[Docket No. FAA-2012-0896; Directorate Identifier 2010-SW-070-AD; Amendment 39-17173; AD 2012-17-10]

Airworthiness Directives; Various Restricted Category Helicopters

ACTION: Final rule; request for comments.

Figure 1 to Paragraph (e)

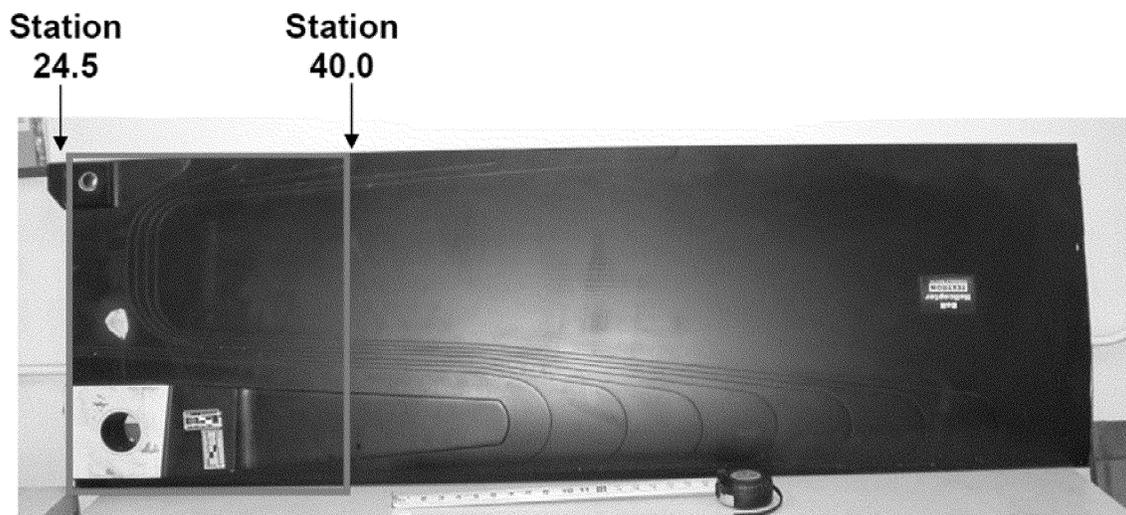
(ii) Using a 3x power or higher magnifying glass and a bright light, on each affected M/R blade, in an area from blade stations 24.5 to 40, including the entire width of the M/R blade chord, as depicted in Figure 1 to Paragraph (e) of this AD:

(A) Visually inspect the upper and lower grip plates and doublers of the M/R blade for an edge void, any corrosion, or a crack.

(B) Visually inspect the remaining upper and lower surfaces of the M/R blade for an edge void, any corrosion, or a crack.

Figure 2 to Paragraph (e)

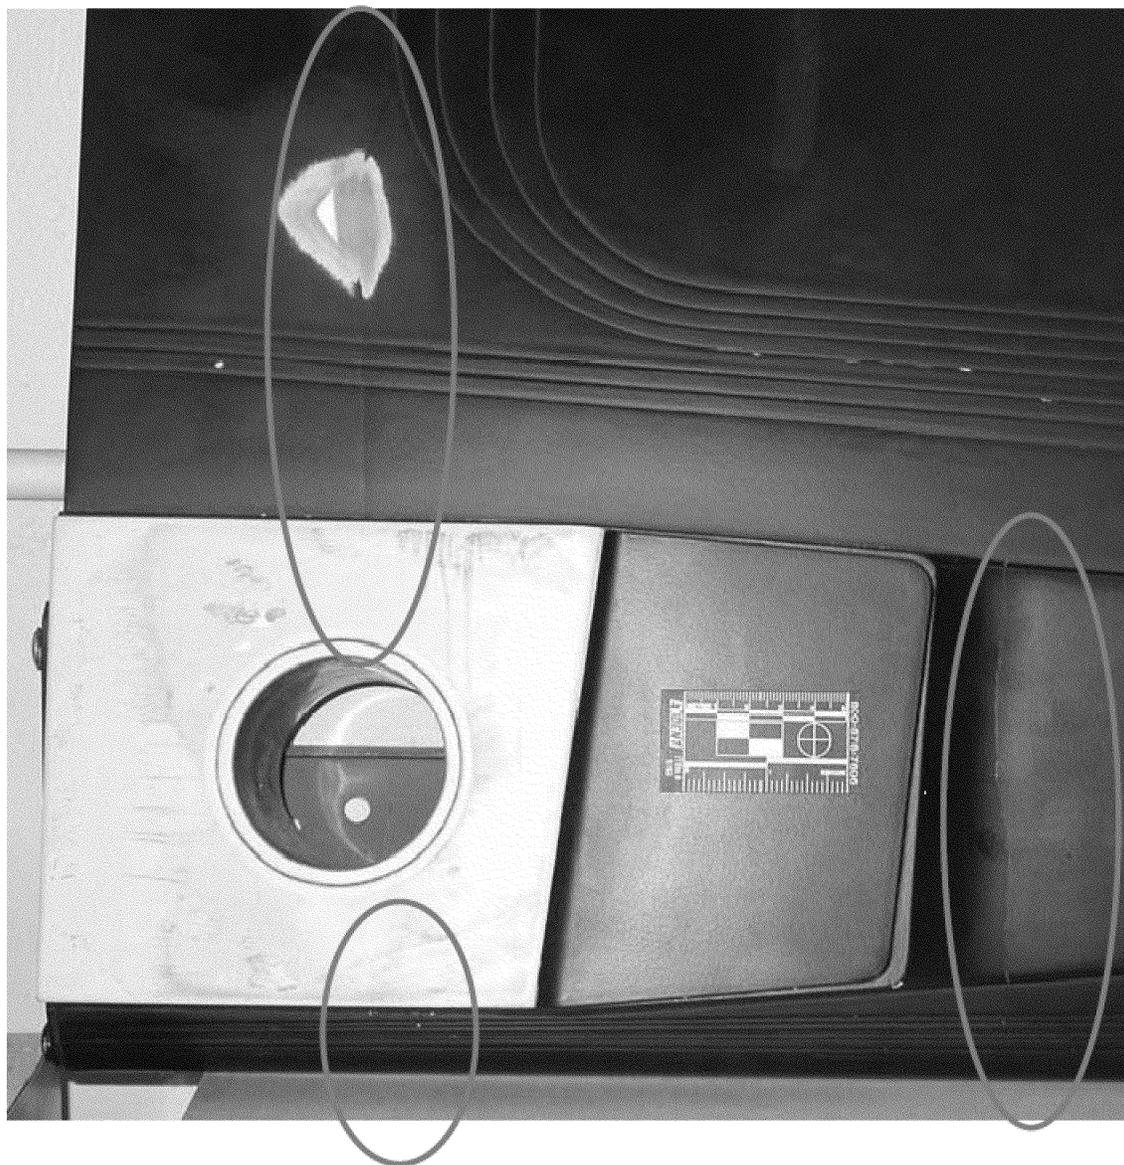
Note 2 to paragraph (e)(1)(ii): Crack indications on an actual M/R blade are shown in Figure 2 to Paragraph (e) of this AD.
